Waste Isolation Pilot Plant Disposal Phase Final Supplemental Environmental Impact Statement

Comment Response Supplement
Volume II
Public Comments

September 1997

Department of Energy
Carlsbad Area Office
Carlsbad, New Mexico

Figure 5. Postulate correlation between oilfield salt water injection and water level rises.

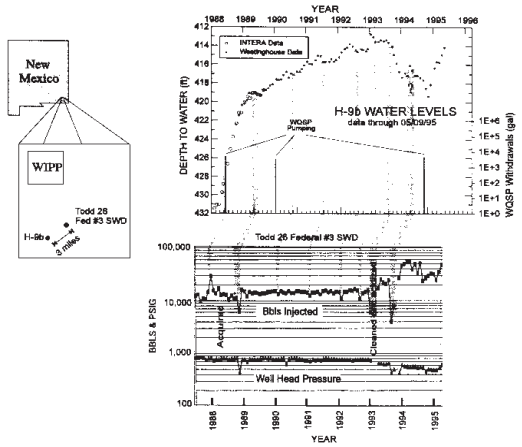
The discussion of the water level rises in the Culebra Aquifer and the potential impact of salt water disposal wells would be clearer by preparing and presenting a figure such as the one shown below and published in EEG-62.
